Maule Aircraft Corporation

SERVICE LETTER #38

SUBJECT: Possible float plane reinforcement deficiency.

MODELS AFFECTED: M-5-235C, S/N 7073C thru 7077C, 7079C, and 7085C.

SERVICE LETTER #38

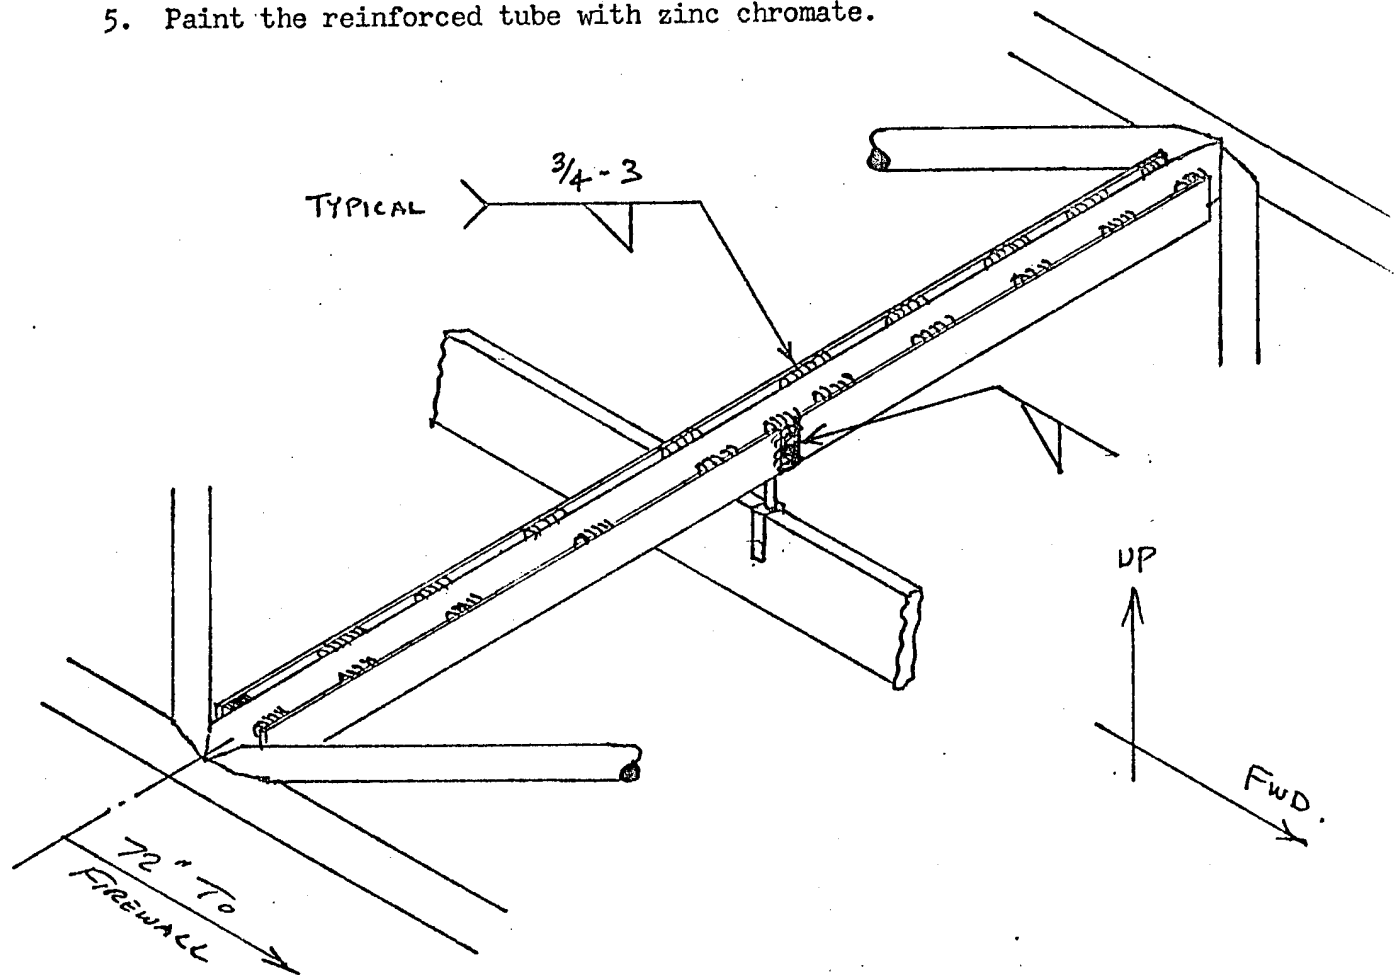
BACKGROUND: There is a possibility that tube #127 (Fuselage bottom, transverse, at the rear/cargo door junction) was not reinforced when the float plane reinforcement kit was installed on these airplanes.

Inspect the subject tube to determine its diameter. The tube in question is on the fuselage bottom, running crosswise, 72 inches aft of the firewall. If this tube is 7/8 inch in diameter, your airplane has the proper reinforcement. So indicate on the Service Letter Compliance Record and return it to us.

If the tube is 3/4 inch in diameter, the float plane reinforcement was not installed on this tube. If you now have the aircraft mounted on floats, you must install this reinforcement before you fly it again.

1. Slide reinforcing tube into fuselage belly below and behind tube to be reinforced, with the channel opening up and the slot forward.
2. Align the slot in the reinforcement with the fabric Stand-off tube and slide the reinforcement up around tube #127, still with the channel opening up.
3. Clamp the reinforcement to the tube and weld both sides of the channel, at the top, to the tube, using a $3/4$ inch fillet weld every three inches.

4. Weld slot closed.
5. Paint the reinforced tube with zinc chromate.
